GROUP
Safety Recall
Campaign

MODEL
2006~2014MY
Sedona (VQ)

NUMBER
SC134 Rev 1, 9/2/2016

**SUBJECT: SECONDARY HOOD LATCH REPLACEMENT OR INSPECTION
AND LUBRICANT APPLICATION (SC134)**

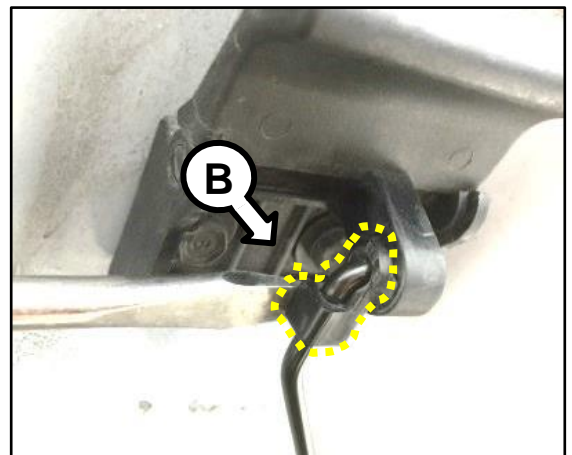
1. Open the hood and remove the bolt (A) securing the secondary hood latch.

2. Remove the secondary hood latch release lever rod from the clip (B) attached to the release lever.

3. Install the improved secondary hood latch in the reverse order of removal. Verify proper operation of secondary hood latch while opening and closing the hood. Ensure the secondary hood latch keeps the hood from opening unless the secondary hood latch release is activated.

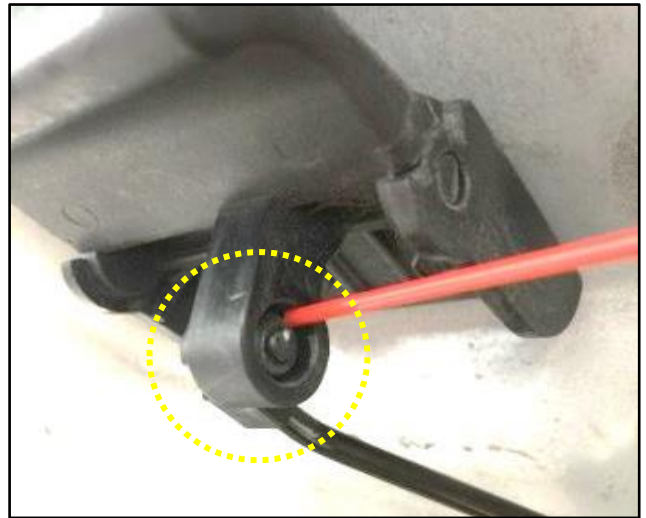
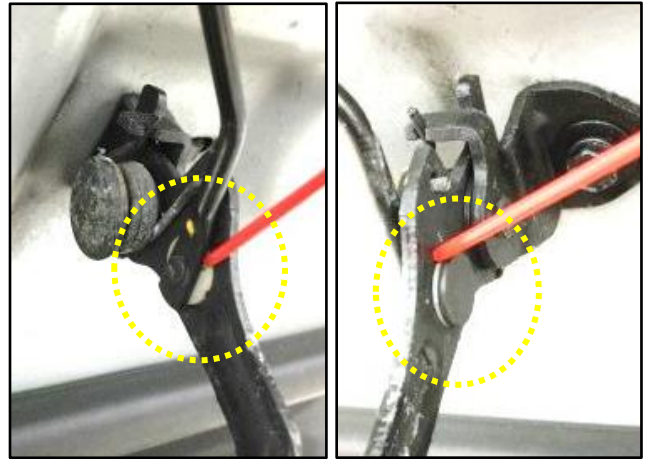
1. Open the hood and inspect the operation of the secondary hood latch.

★ NOTICE**Operate the secondary hood latch.**

- If there is no evidence of sticking or binding, apply WD-40 Specialist Lubricant on the rod riveting area.
- If the latch is sticking or binding, replace the latch per steps 1-3 on page 2.

1. Apply a sufficient amount of WD-40 Specialist lubricant onto rod, riveting area, and clip.

2. Verify proper operating of secondary hood latch. Wipe off any excess lubricant.
